Product Change Notice (PCN)

PCN Number: **PCN-0454759R-01**

Product(s) Affected: SJ2-25414D-SMT-TR

PREVIOUS CUI DEVICES DETAIL / IMAGE	NEW CUI DEVICES DETAIL / IMAGE

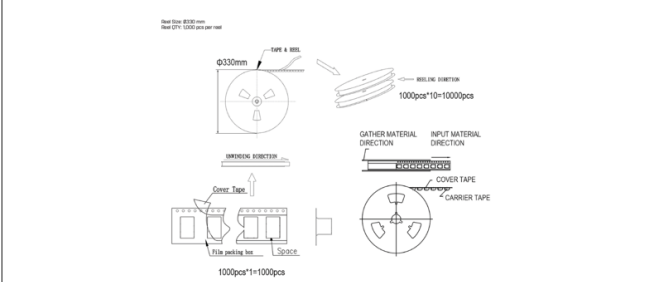
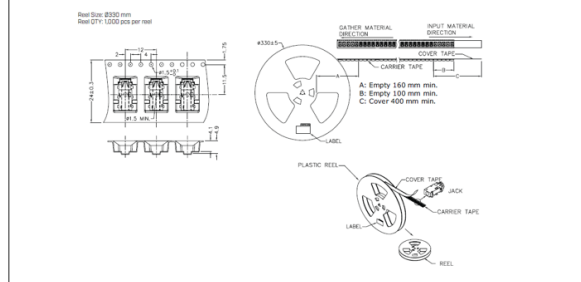
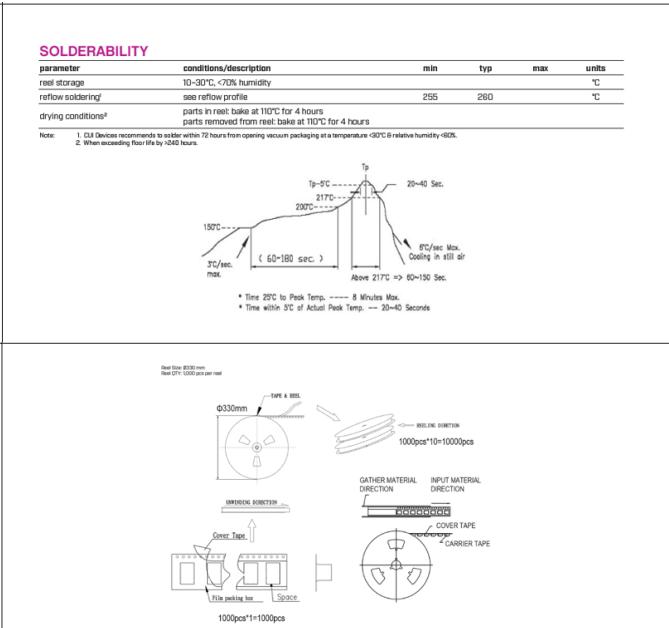
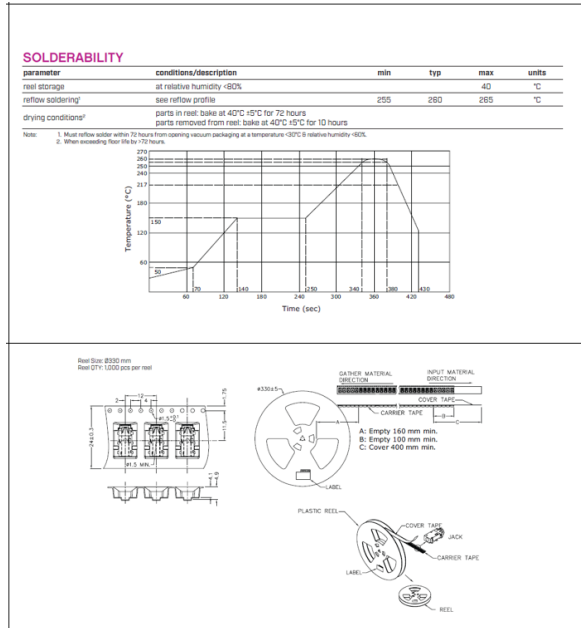
Description of Change: mechanical, material, packaging, and soldering differences as shown below:

<p>Recommended PCB Layout Top View</p>	 <p>Recommended PCB Layout Top View</p>																																																
<table border="1"> <thead> <tr> <th></th> <th>MATERIAL</th> <th>PLATING</th> </tr> </thead> <tbody> <tr> <td>terminal 1</td> <td>copper alloy</td> <td>gold flash</td> </tr> <tr> <td>terminal 2</td> <td>Ti-Cu</td> <td>gold flash</td> </tr> <tr> <td>terminal 3</td> <td>copper alloy</td> <td>gold flash</td> </tr> <tr> <td>terminal 4</td> <td>copper alloy</td> <td>gold flash</td> </tr> <tr> <td>terminal 10</td> <td>brass</td> <td>gold flash</td> </tr> <tr> <td>terminal 11</td> <td>brass</td> <td>gold flash</td> </tr> <tr> <td>plastic</td> <td>PAIOT</td> <td></td> </tr> </tbody> </table>		MATERIAL	PLATING	terminal 1	copper alloy	gold flash	terminal 2	Ti-Cu	gold flash	terminal 3	copper alloy	gold flash	terminal 4	copper alloy	gold flash	terminal 10	brass	gold flash	terminal 11	brass	gold flash	plastic	PAIOT		<table border="1"> <thead> <tr> <th>DESCRIPTION</th> <th>MATERIAL</th> <th>PLATING/COLOR</th> </tr> </thead> <tbody> <tr> <td>terminal 1</td> <td>phosphorus bronze</td> <td>gold</td> </tr> <tr> <td>terminal 2</td> <td>beryllium bronze</td> <td>gold</td> </tr> <tr> <td>terminal 3</td> <td>beryllium bronze</td> <td>gold</td> </tr> <tr> <td>terminal 4</td> <td>beryllium bronze</td> <td>gold</td> </tr> <tr> <td>terminal 10</td> <td>phosphorus bronze</td> <td>gold</td> </tr> <tr> <td>terminal 11</td> <td>phosphorus bronze</td> <td>gold</td> </tr> <tr> <td>housing</td> <td>PPA (UL94V-0)</td> <td>black</td> </tr> </tbody> </table>	DESCRIPTION	MATERIAL	PLATING/COLOR	terminal 1	phosphorus bronze	gold	terminal 2	beryllium bronze	gold	terminal 3	beryllium bronze	gold	terminal 4	beryllium bronze	gold	terminal 10	phosphorus bronze	gold	terminal 11	phosphorus bronze	gold	housing	PPA (UL94V-0)	black

MATERIAL	PLATING																																															
terminal 1	copper alloy	gold flash																																															
terminal 2	Ti-Cu	gold flash																																															
terminal 3	copper alloy	gold flash																																															
terminal 4	copper alloy	gold flash																																															
terminal 10	brass	gold flash																																															
terminal 11	brass	gold flash																																															
plastic	PAIOT																																																
DESCRIPTION	MATERIAL	PLATING/COLOR																																															
terminal 1	phosphorus bronze	gold																																															
terminal 2	beryllium bronze	gold																																															
terminal 3	beryllium bronze	gold

terminal 4	beryllium bronze	gold																																															
terminal 10	phosphorus bronze	gold																																															
terminal 11	phosphorus bronze	gold																																															
housing	PPA (UL94V-0)	black
